APPEAL STAFF REPORT SUBSTANTIAL ISSUE DETERMINATION ONLY

Appeal number	.A-3-SCO-11-044, Pitt Riparian Development	
Applicant	.Michael Pitt	
Appellant	Commissioners Brian Brennan and Mark Stone; Claudia Slater	
Local government	.Santa Cruz County	
	Coastal Development Permit (CDP) Application Number 101078 approved by the Santa Cruz County Zoning Administrator on June 17, 2011.	
·	Just upslope of Corcoran Lagoon in the riparian corridor on the lagoon side of 391 24th Avenue in the Live Oak beach area of Santa Cruz County (APN 028-181-05).	
Project description	Construction of retaining walls, concrete stairs, and associated residential use areas (some after-the fact), shed demolition, and riparian restoration.	
File documents	Final Local Action Notice for Santa Cruz County CDP Number 101078; Santa Cruz County certified Local Coastal Program (LCP).	
Staff recommendationSubstantial Issue Exists

County of Santa Cruz, PLANNING DEPARTMENT Discretionary Application Comments 101078 APN 028-181-05

Figure 1. Recommended Restoration and Enhancement Areas

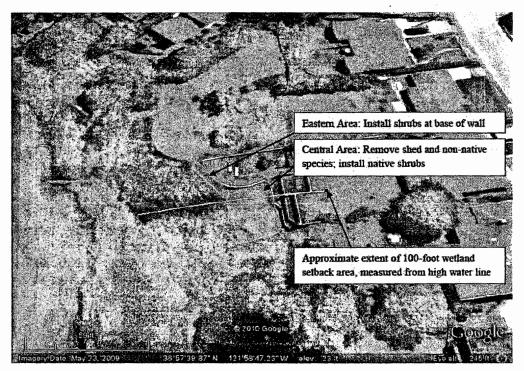
The areas recommended for restoration and enhancements are down slope of the lowest retaining wall, as depicted on Figure 1.

Restoration actions within the two treatment areas, as depicted on Figure 1, are outlined below.
